DART SERVICE INSTRUCTION

TO AMEND INSTALLATION INSTRUCTIONS IIN-D135-692 REV. A

REF. FAA STC: SR01042SE

FIGURE 1: D135-692-041 WEARPLATE KIT

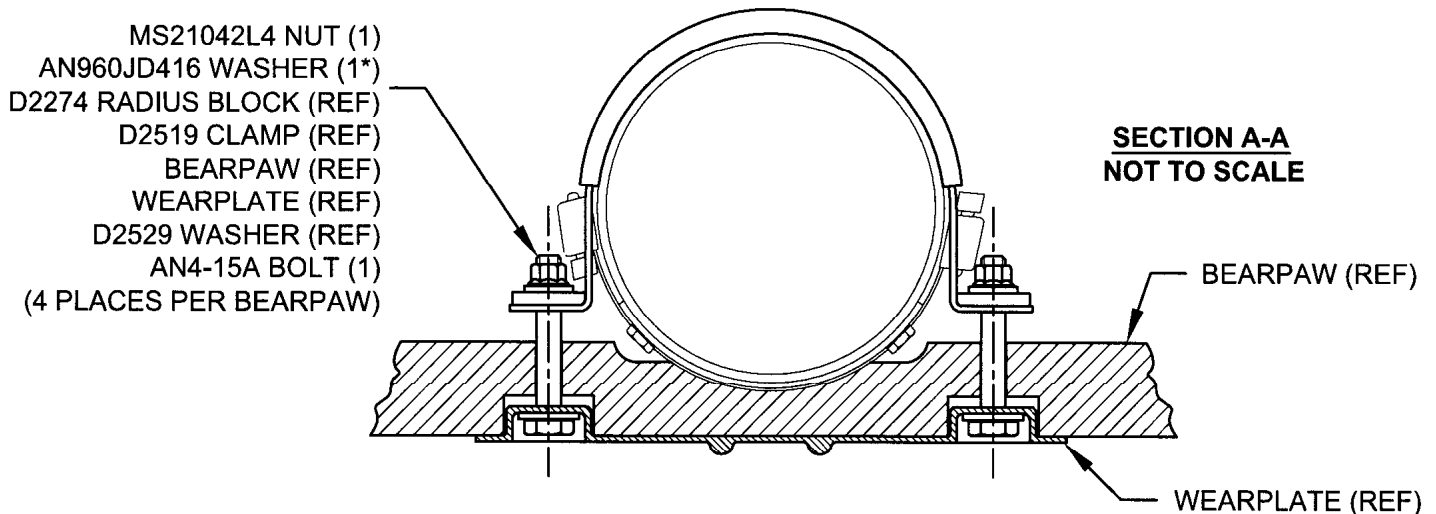
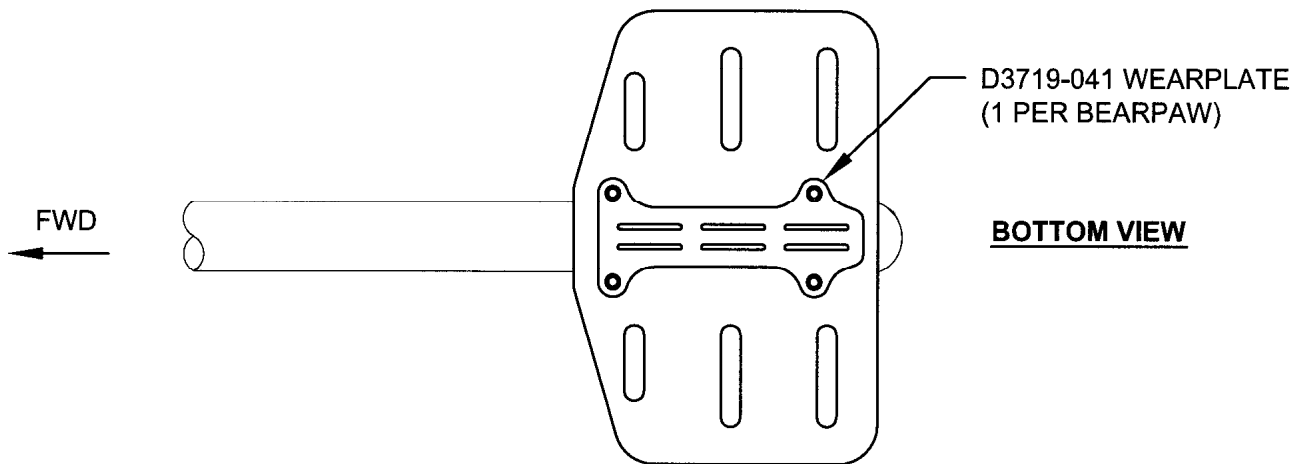
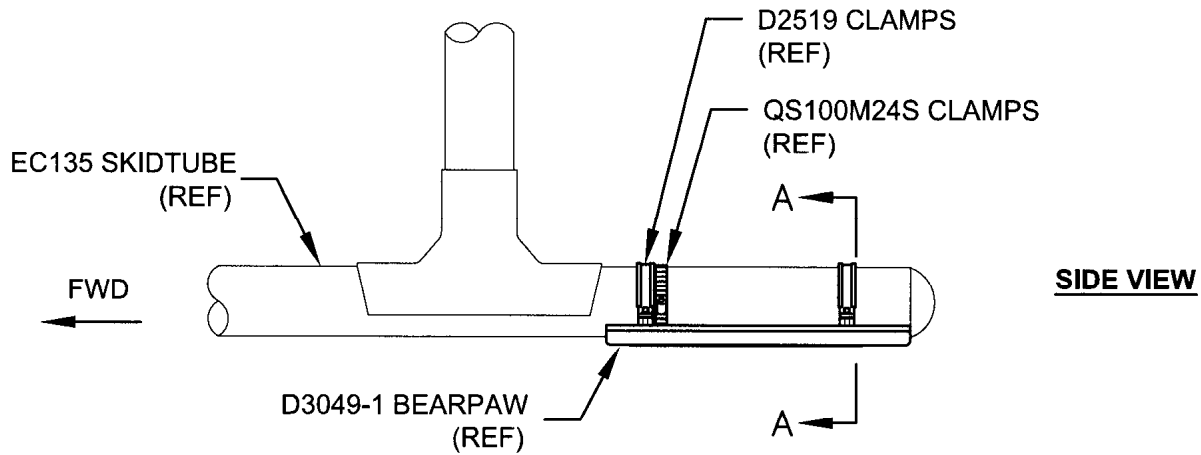
The D135-692-041 Wearplate Kit can be installed on Dart D135-692-011 Bearpaw Installations. The D3719-041 Wearplates should be installed on the D3049-1 Bearpaws as shown in Figure 1 on sheet 2 of this service instruction. The bearpaw should otherwise be installed on the skidtube per installation instructions IIN-D135-692 Rev. A.

* ADDITIONAL AN960JD416 WASHERS MAY BE INSTALLED UNDER THE NUTS TO ENSURE 1.5-4 THREADS IN SAFETY ON THE BOLTS. IT IS ALSO ACCEPTABLE TO REPLACE THE AN4-15A BOLTS WITH LONGER OR SHORTER AN4 BOLTS, IF REQUIRED.
